## FURTHER ADVICE RESPONSE

### RESPONSE TO FURTHER ADVICE LETTER – 140 FRASERS ROAD, MITCHELTON (APPLICATION REFERENCE - A006836143)

On behalf of *Salt Typhoon Pty Ltd*, please find below a full response to the Further Advice Letter sent by Council on 3 February 2026 in relation to the above-mentioned development application.

Figure 1: The proposed tree to be removed in red and the nearby tree in green.

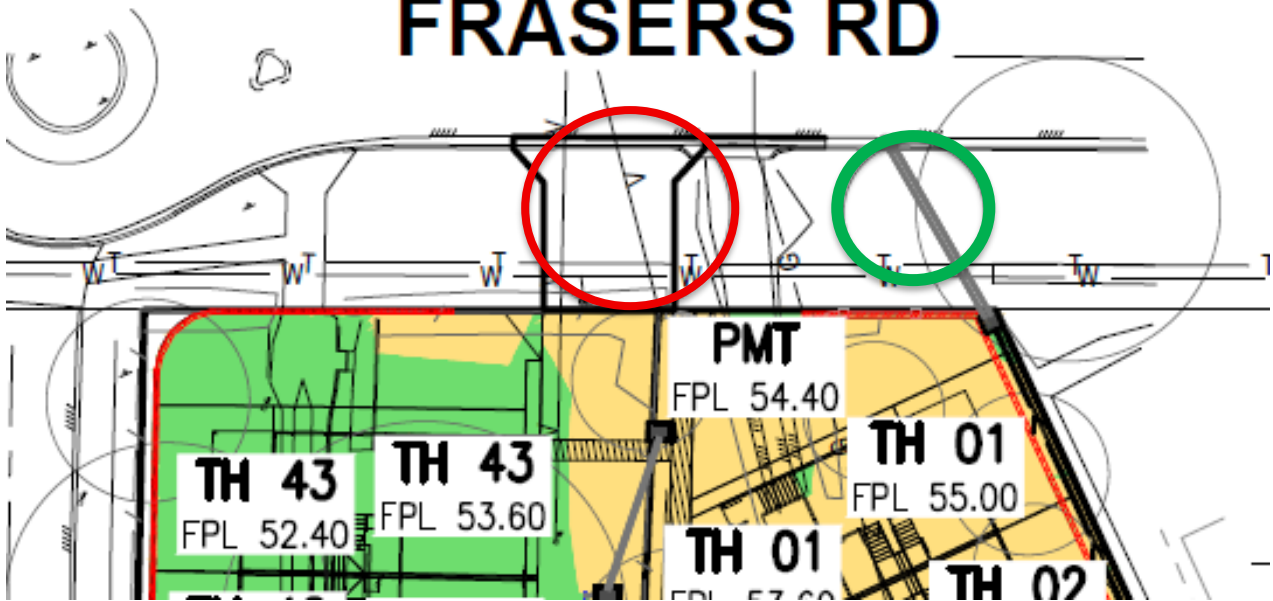
- a) Details about planting areas along driveways to accommodate large shade trees with adequate soil volumes and clearances to ensure long-term tree health. Where trees are provided within communal open space, demonstrate how these trees will enhance the shading and utilisation of the communal open space, e.g. placed around communal seating or play areas, etc.*
- b) Green space areas abutting the waterway corridor to comprise a planting palette of native plant species mix (consistent with species present within RE12.11.3).*
- c) Ensure a minimum of two (2) metres between the new driveway access and the street trees on Frasers Road. Where a street tree is proposed to be removed, identify and assess its existing condition within the updated Arboricultural report/Tree retention plan.*

One existing street tree is to be removed as part of the proposal (refer to Figure 1). The crossover will be greater than the 2.0m from the nearby street tree.

It was confirmed by the previous assessment manager that there was no issue with the removal of the street tree, nor was it raised in the previous Information Request.

Notwithstanding the above, the applicant will accept a replacement street tree condition.

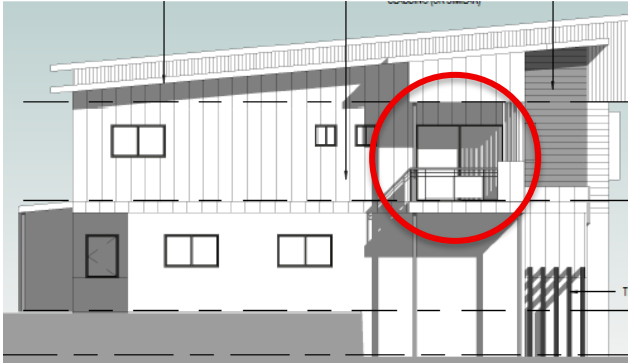
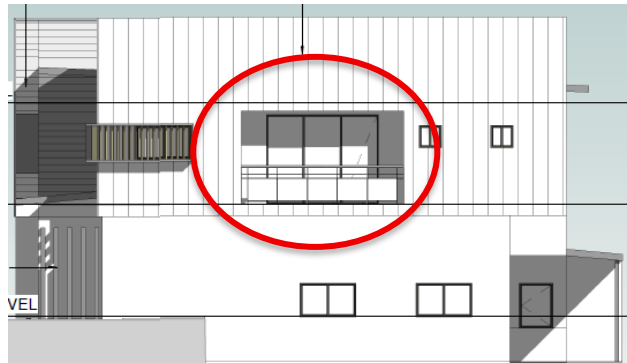
There is also still a concern about the lack of orientation of the two townhouses to the street frontage as no balconies have been orientated to the street. The Information Request response to this matter is not satisfactory. Main living areas and windows have not been designed to provide casual surveillance of the street.

- Provide amended plans showing balconies for TH1 and TH43 facing the street.
- Provide amended plans showing window projections/hoods that better address the subtropical design requirements of the Multiple dwelling code, particularly windows facing north and northwest. The development should also ensure that the 1m wide footpath is separate to the vehicle access and distinct in terms of the underlying substrate and materials e.g. exposed aggregate concrete or brick pavers for the pedestrian path to contrast with finish for the driveway. The driveway entry from Frasers Road also requires further variation to limit visual amenity impacts to the street.

Balconies have been incorporated for TH1 and TH43, where facing the street (see below).
